# Wollongong Local Planning Panel Assessment Report | 20 October 2020

<b>WLPP No.</b>	Item No. 3
<b>DA No.</b>	DA-2020/632
<b>Proposal</b>	Residential – demolition of existing buildings, remove eight (8) trees, construction of multi dwelling housing – eight (8) units and Subdivision – Strata title – eight (8) lots
<b>Property</b>	14 & 16 Acacia Avenue, Gwynneville
<b>Applicant</b>	10 Star Pty Ltd
<b>Responsible Team</b>	Development Assessment and Certification - City Centre Team (CB)

## ASSESSMENT REPORT AND RECOMMENDATION

Figure 1: Unit 2 non-compliant side setback area highlighted on east elevation

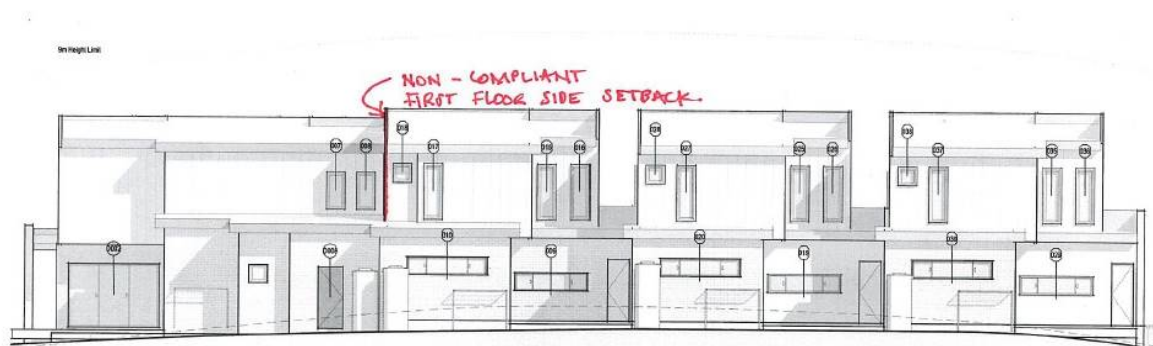
The minimum eastern side setback for Unit 2 is 4.376 metres which is non-compliant with the minimum calculated requirement of 4.384 metres [cl 5.4.2 (1)]. The length of the non-compliant section is about 10cm and the extent of the non-compliance is 8mm which is considered very minor. The variation is not considered to have a considerable impact upon the surrounding area, and is generally consistent with the relevant objectives of the control as outlined below:

The non-compliant section is setback 4.376 metres from the eastern side boundary facing into the neighbouring dwelling at No. 12 Acacia Avenue. This area is shown highlighted in Figure 1. The adjoining neighbour is located to the east of the subject property. Shadow diagrams show that the eastern neighbour will receive adequate solar access to living rooms and POS during the winter solstice. Privacy is maintained as the non-compliant section consists of a small section of a first floor wall. View loss is considered minimal, given the marginal extent of the non-compliant setback.
